# HARNETT CENTRAL PRESS BOX

HARNETT CENTRAL PRESS BOX  
HARNETT COUNTY SCHOOLS  
2911 HARNETT CENTRAL RD, ANGIER, NC 27501

PROJECT INFORMATION:  
DATE: 1/10/2023  
DRAWN BY: RDH  
CHECKED BY: JEL  
SHEET TITLE  
COVER SHEET  
SHEET NUMBER  
G-001  
PROJECT# 21-11110

SHEET NUMBER  
M-101  
PROJECT# 21-11110

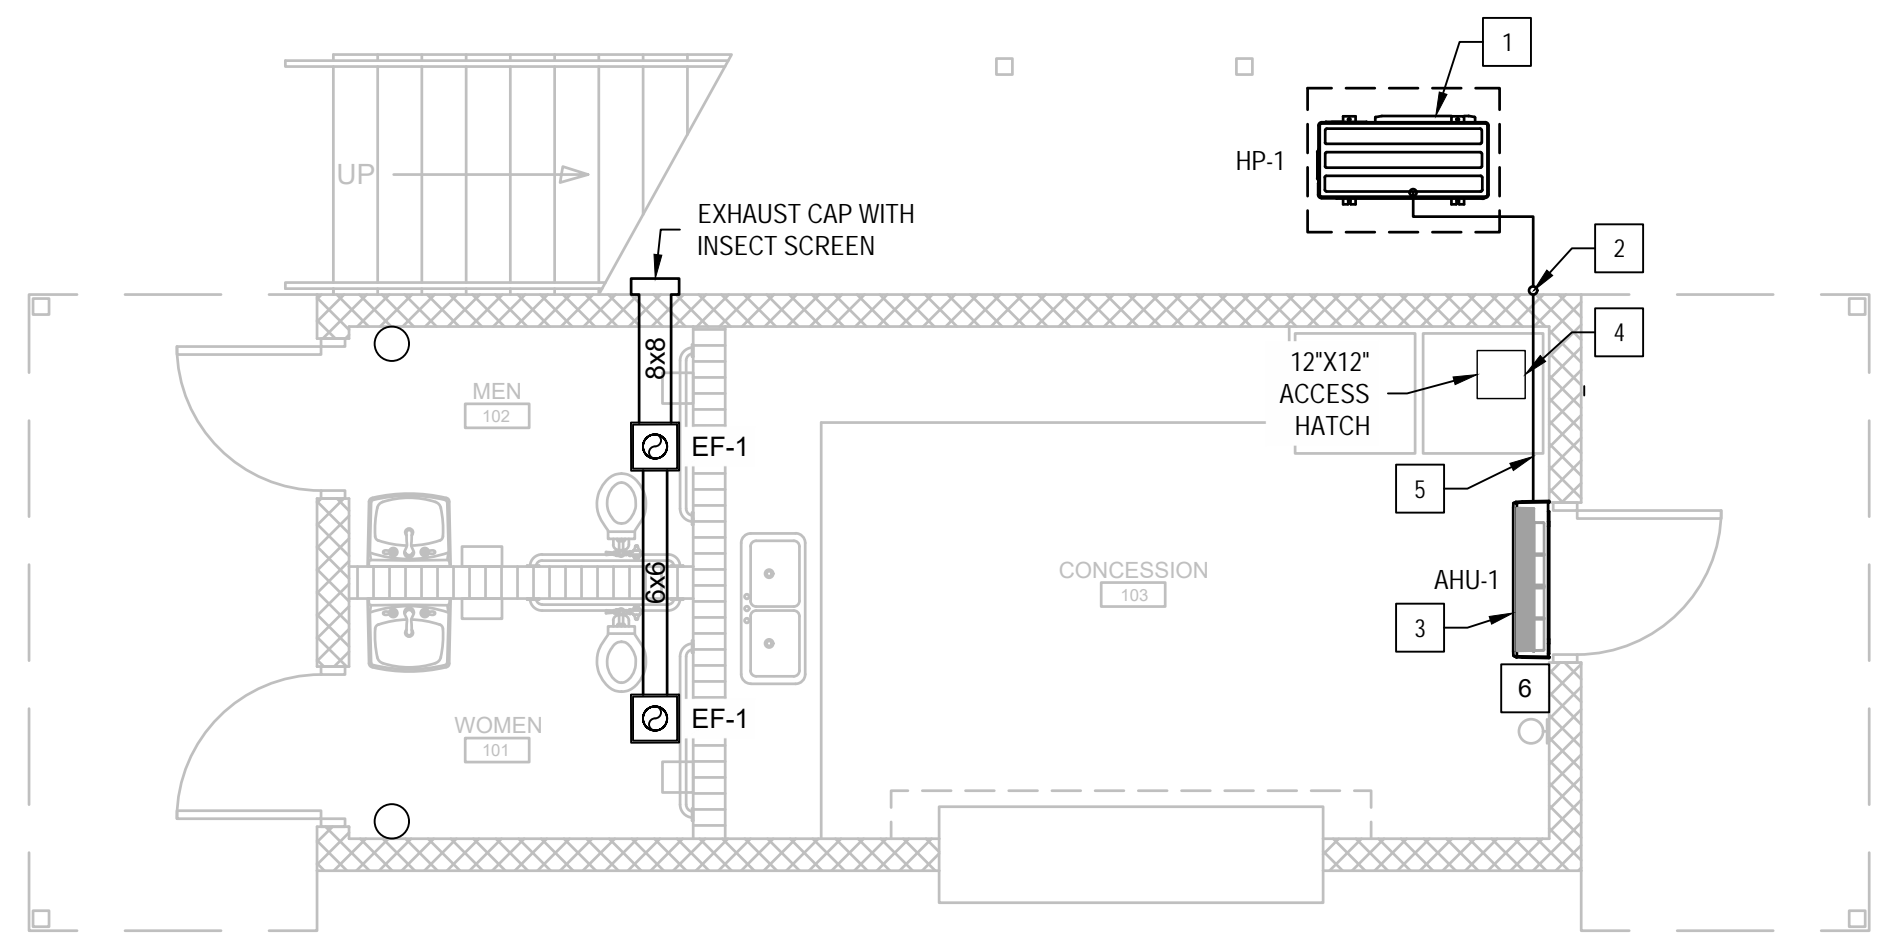
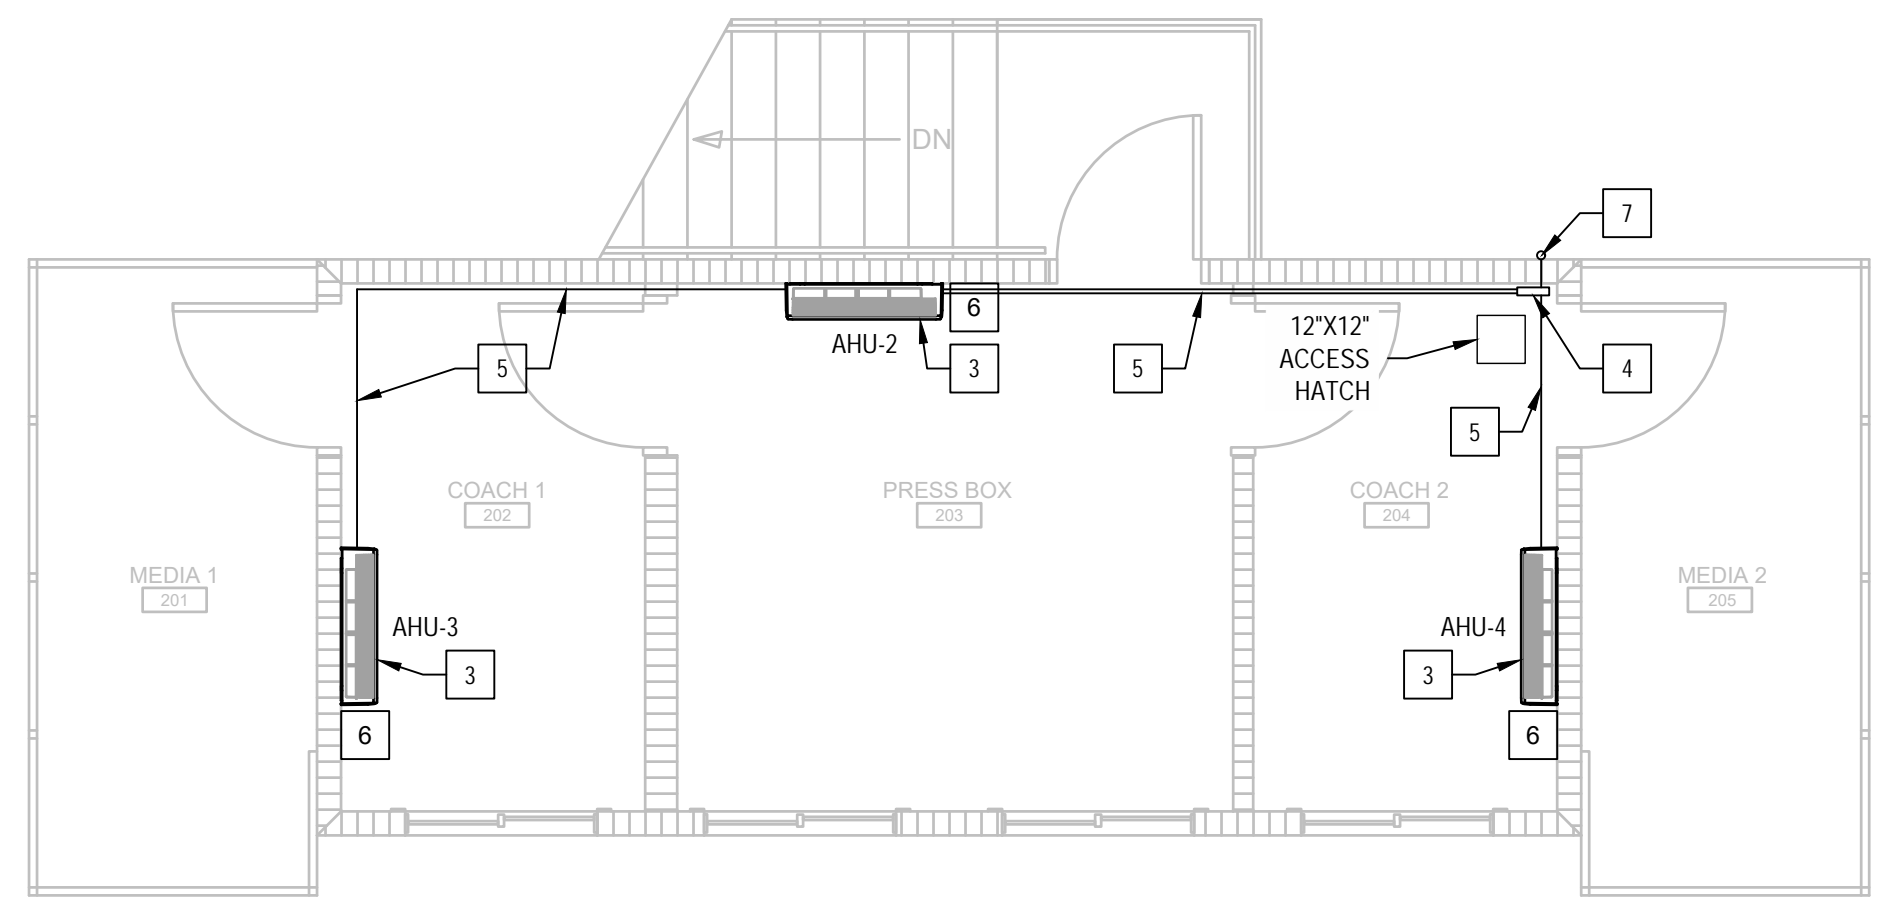
NO.	DATE	DESCRIPTION
1	4/13/2023	EXHAUST FAN MODEL CHANGED

SHEET TITLE:  
**ELECTRICAL LIGHTING PLAN**  
SHEET NUMBER:  
**E-201**  
PROJECT# 21-1110

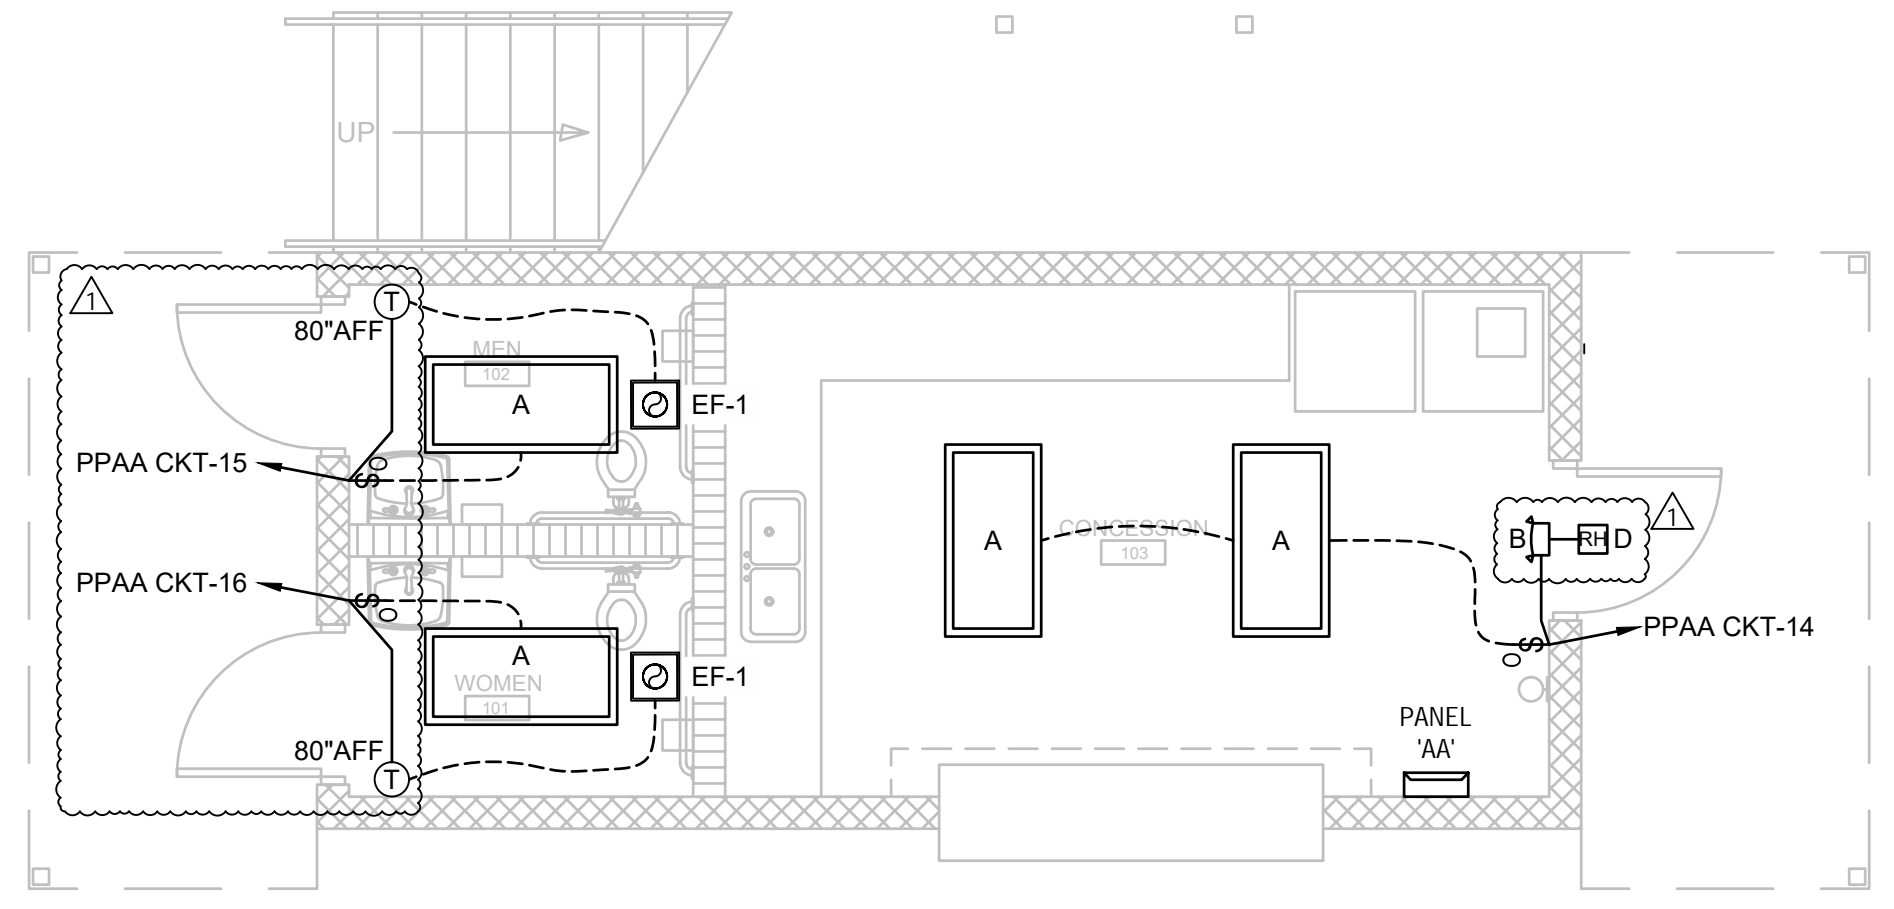
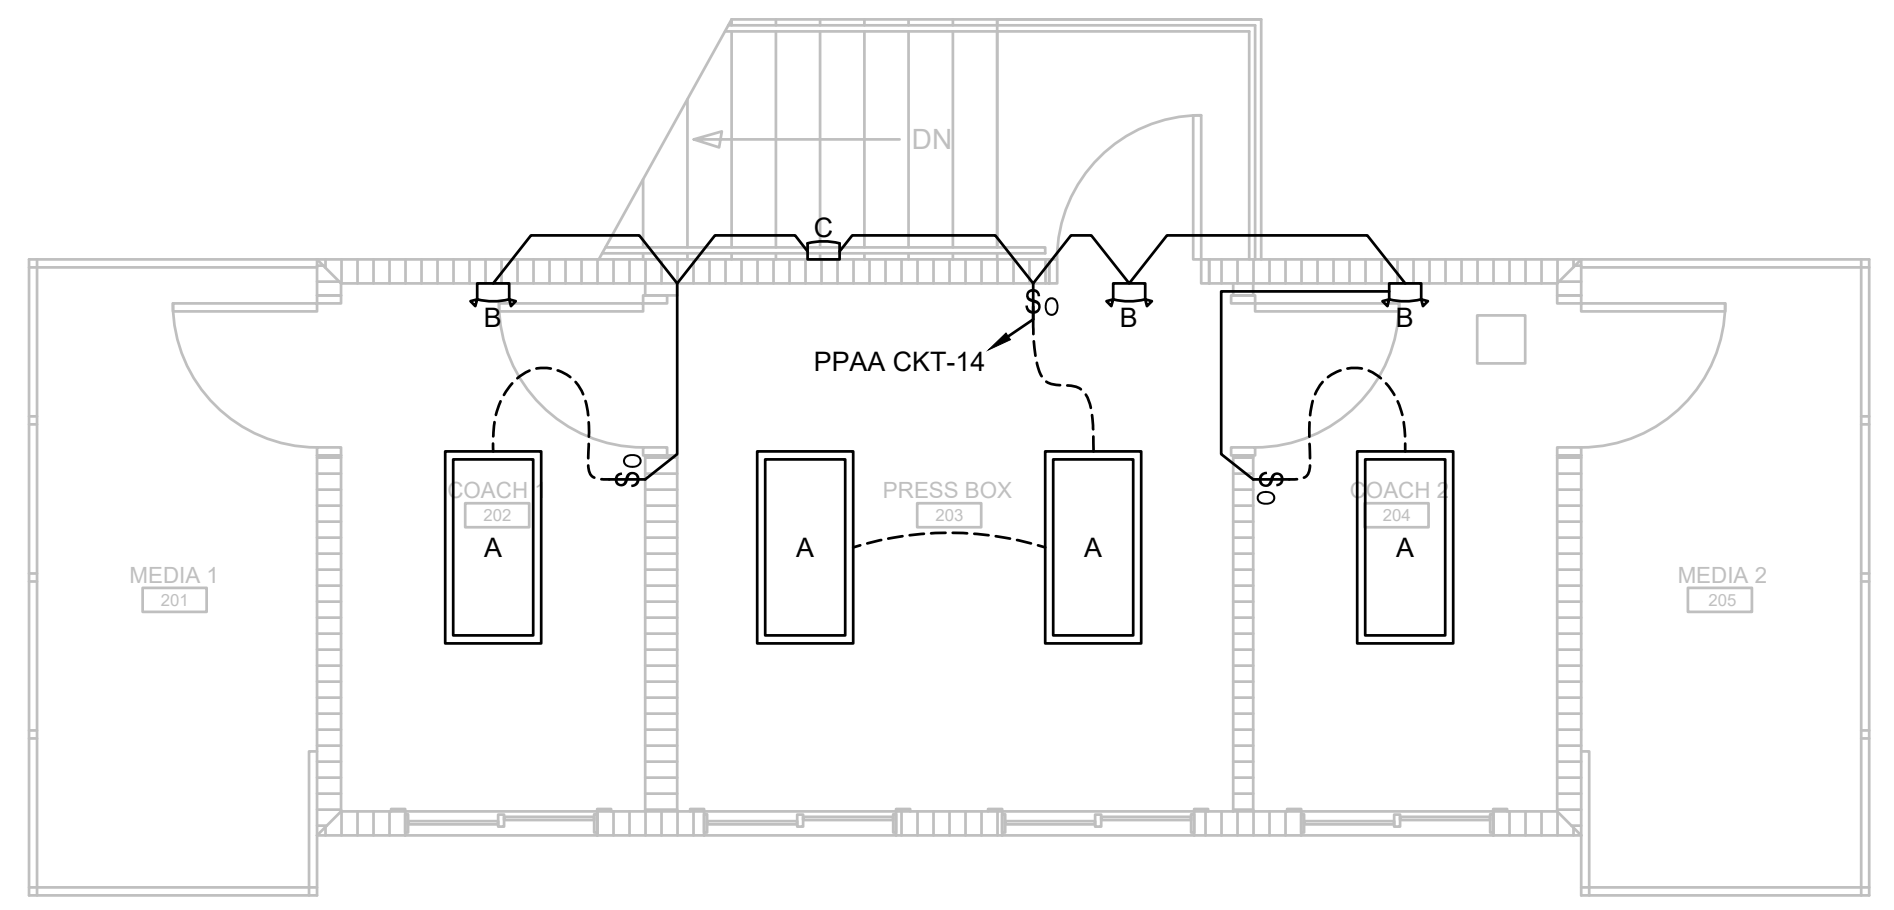
REV#	DATE	DESCRIPTION
1	4/12/2023	EXT FAN CHANGED, CONCESSIONS DIER, LOT RELOCATED AND REMOTE ID ADDED.
2		
3		
4		
5
